[Docket No. FAA-2023-0672; Project Identifier AD-2022-01429-T]

Airworthiness Directives; The Boeing Company Airplanes

ACTION: Notice of proposed rulemaking (NPRM).

The Boeing Company Airplanes: Docket No. FAA-2023-0672; Project Identifier AD-2022-01429-T.

Figure 1 to paragraph (g)(2)(i)—*Fundamental Effective Isotropic PSD at Outside Interface of Aircraft Antenna*

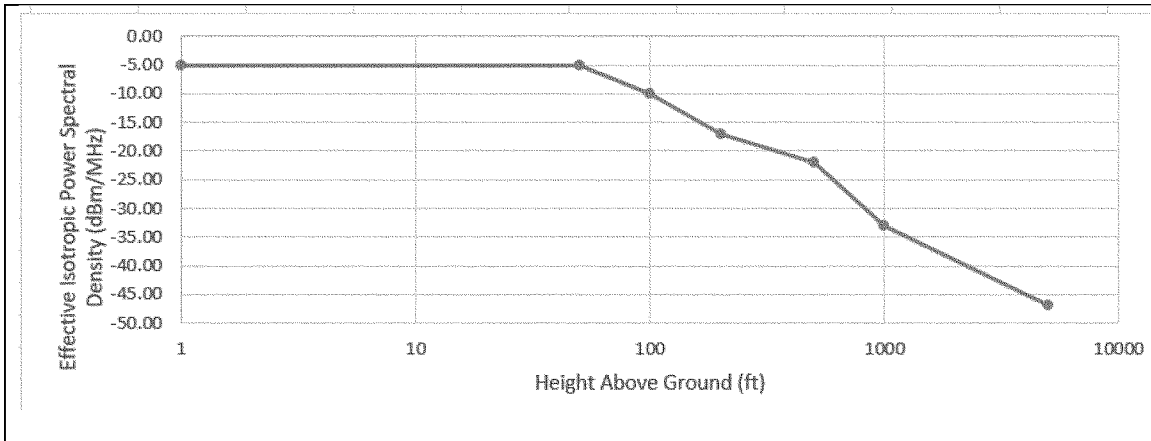
(i) Tolerance to radio altimeter interference, for the fundamental emissions (3.7–3.98 GHz), at or above the power spectral density (PSD) curve threshold specified in figure 1 to paragraph (g)(2)(i) of this AD.

Height above ground (ft)	Effective Isotropic PSD (dBm/MHz)
Aircraft on the ground	-5
50	-5
100	-10
200	-17
500	-22
1000	-33
5000	-47

Figure 2 to paragraph (g)(2)(ii)—*Spurious Effective Isotropic PSD at Outside Interface of Aircraft Antenna*

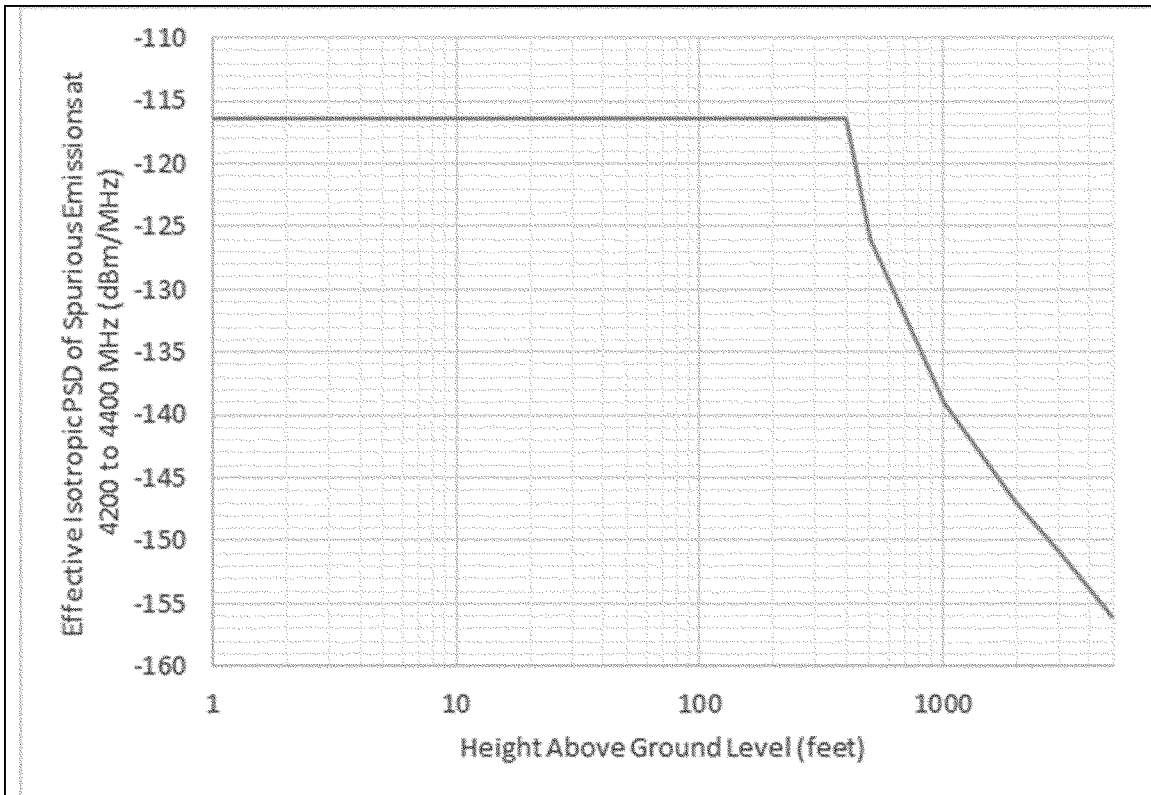
(ii) Tolerance to radio altimeter interference, for the spurious emissions (4.2–4.4 GHz), at or above the PSD curve threshold

specified in figure 2 to paragraph (g)(2)(ii) of this AD.

<u>Aircraft Altitude (ft AGL)</u>	<u>Effective Isotropic PSD (dBm/MHz)</u>
1	-116.50
400	-116.50
500	-126.00
1000	-139.00
2000	-147.00
3000	-151.00
5000	-156.00
